**STAFF REPORT: FEBRUARY 23, 2022 MEETING**

**APPLICATION NUMBER: 22-7674**

**ADDRESS: 14831 WARWICK**

**SCOPE: REPLACE WOOD DOOR WITH FIBERGLASS DOOR**

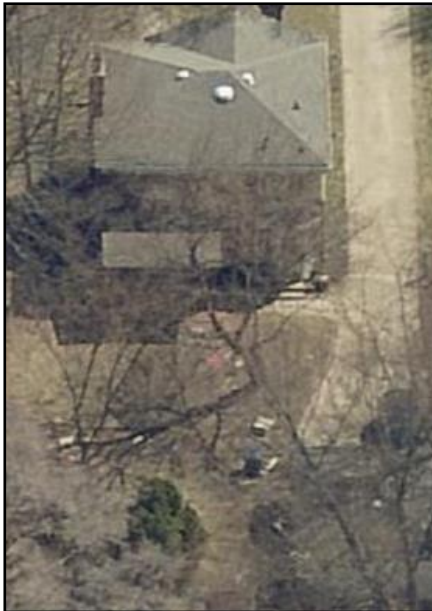
- Staff understands the safety concerns, especially after the applicant had the experience of confronting an intruder. It is not clear to staff, however, if the existing entry door can be retrofitted with components to increase the security while retaining the historic architectural design of this main entryway.
  - One pane of glass was replaced due to the recent break-in attempt. Staff asked the applicant to investigate if laminated glass could be installed within the nine small openings and retain the

- The condition of the door does not appear to be deteriorated beyond repair. The mold on the door may likely be remediated by a cleaning (and maybe repainting) and the mold around the recently installed glass panel might be mitigated by the installation of laminated glass and subsequent repair to the seam created for the single pane glass installation.

- The proposed fiberglass door design has an ornate, simulated leaded-glass design which is not in keeping with the post-war classical revival architecture of the house. Staff identifies the door as a character-defining feature of the front elevation; the district's Elements of Design broadly discuss these features:

It is staff's opinion the replacement of the wood entry door and installation of the fiberglass entry door, as proposed, will alter the features and spaces that characterize the property. Staff therefore recommends the Commission deny a Certificate of Appropriateness for the work as proposed because it does not meet the Secretary of the Interior Standards for Rehabilitation and the Elements of Design for the district, specifically Standards:

ANDERSEN® 4000 SERIES FULLVIEW STORM DOOR WITH CLEAR GLASS

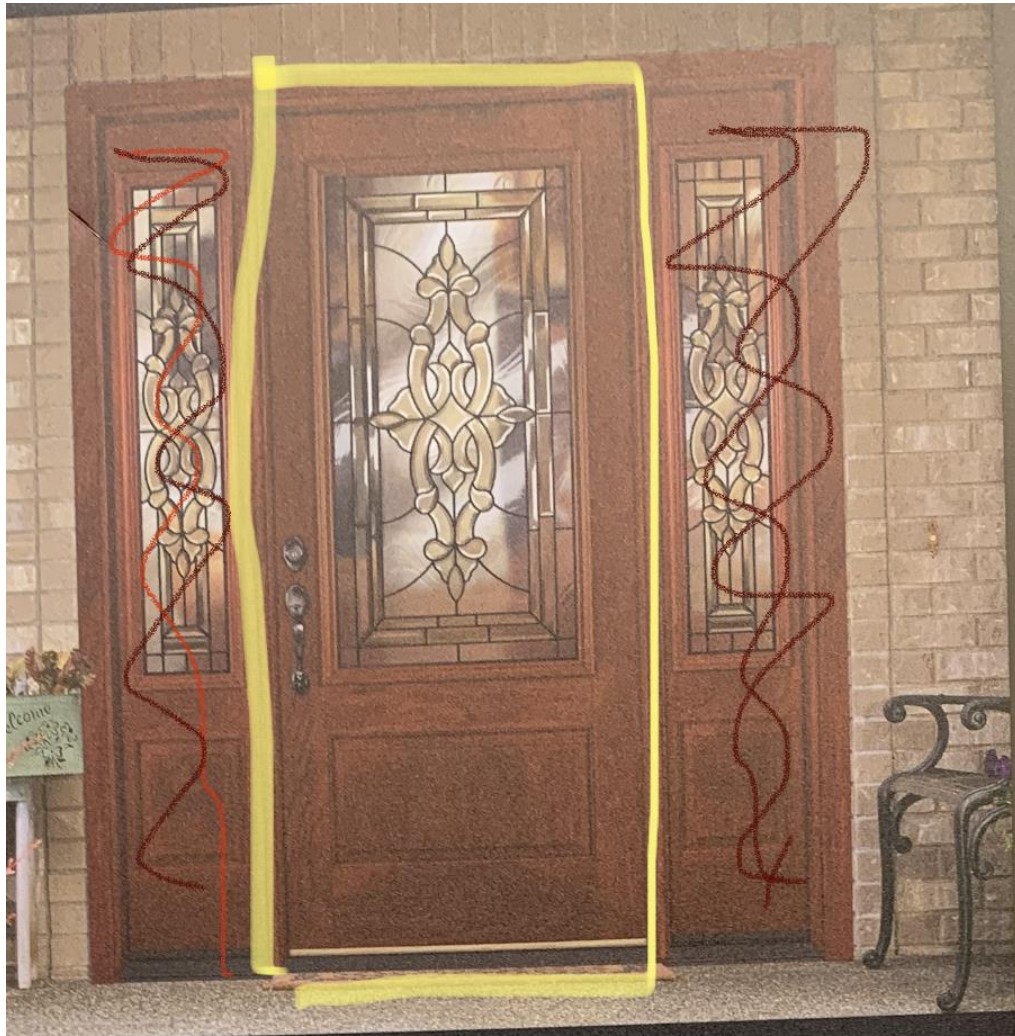
- It is staff's opinion storm doors are often replaced due to the wear-and-tear of exposure to weather and UV rays. While the current storm door matches the design of the entry door, it is staff's opinion the character-defining features of the front entrance are the wood components comprised of the columns and true divided-light entrance door. Replacement of the existing storm door with the proposed full-glass door offers an unobstructed view of the wood door. Or, for further safety considerations, the owner could consider a security safety door. Depending on the design and color, the storm door replacement might be approved at a staff level.

It is staff's opinion the replacement of the steel storm door and installation of the fiberglass storm door, as proposed, will not alter the features and spaces that characterize the property. Staff therefore recommends the Commission issue a Certificate of Appropriateness for the work as proposed because it does meet the Secretary of the Interior Standards for Rehabilitation and the Elements of Design for the district.
